JABIRU AIRCRAFT PTY LTD

SERVICE BULLETIN: JSB 025-2
Issue: 2
Date: 7th May 2009
Subject: Undercarriage Bolt Life

Figure 1 – Undercarriage

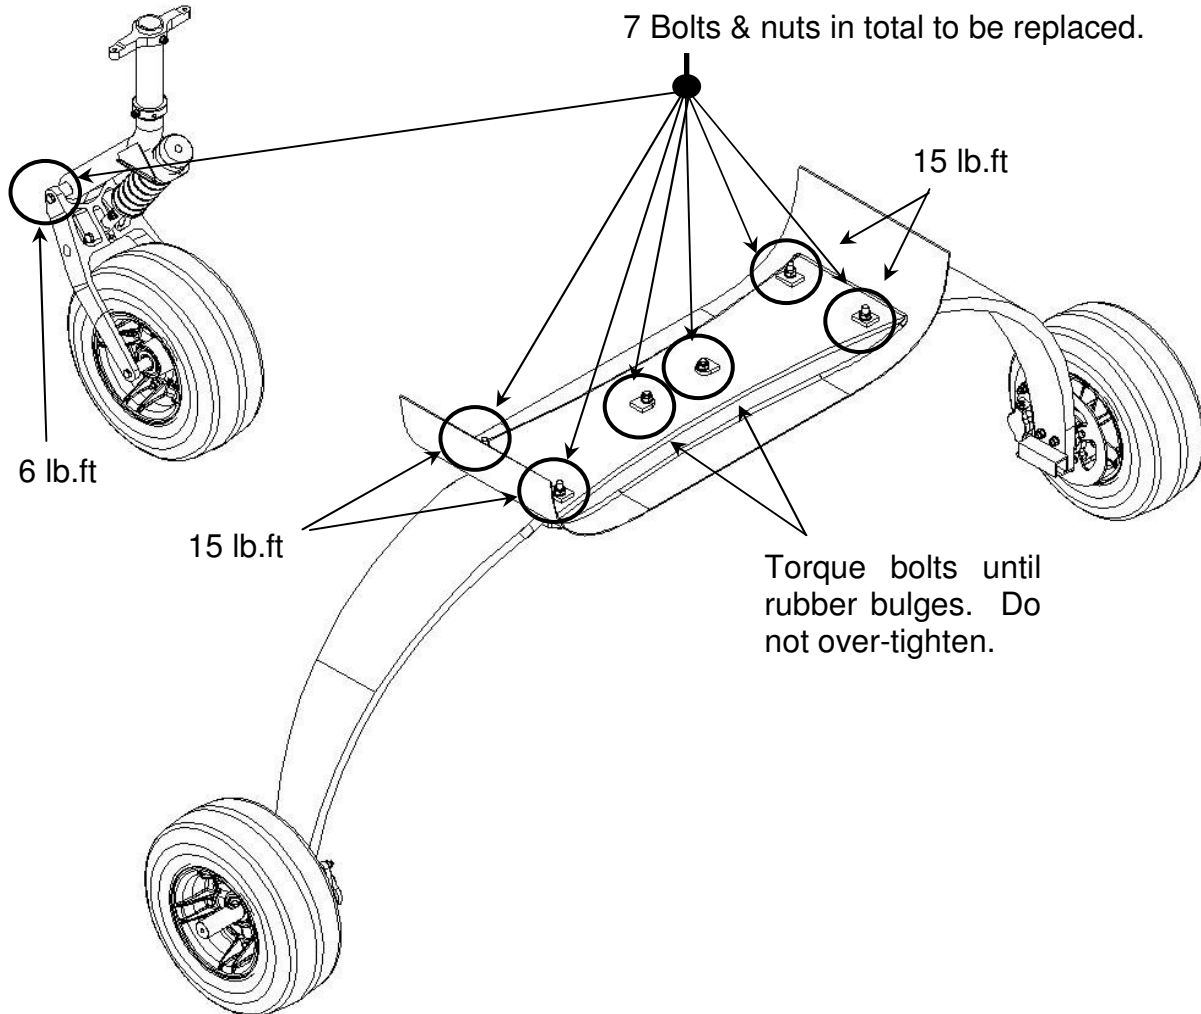
- Bolts and nuts used in the positions shown in Figure 1 are to be replaced after 500 hours Time In Service (TIS).
- Bolts which have already surpassed 500 hours TIS are to be replaced at the aircraft's next 100-hourly or annual inspection.

- A procedure for removing the undercarriage legs is given in the Technical Manuals of all Jabiru Aircraft and is to be used for this task.
- Figure 1 shows a general schematic of a tricycle undercarriage for a Jabiru Aircraft. The bolts which are to be replaced are indicated. While there are detail differences between Jabiru models all have the same general layout and have the same critical 7 bolts which are to be replaced.
- Note that the length of the bolts used in each position is not fixed – that is, the left-rear bolt of aircraft "A" is not necessarily the same length as the left-rear bolt of aircraft "B".

The length of the new bolt fitted should match that of the old bolt being removed. Please confirm the correct length of the bolts for your aircraft before ordering bolt kits.

- Standard aircraft practices apply to nuts: when tightened no less than 1 and no more than 3 threads must show through the nut.
- For tail-dragger models the 6 bolts retaining the main (front) undercarriage legs are to be replaced. No specific bolts are required to be replaced in the tail wheel assembly.
- The old bolts and the aircraft components are to be inspected while disassembled for indications of looseness, fretting or other damage and repaired / replaced as necessary.
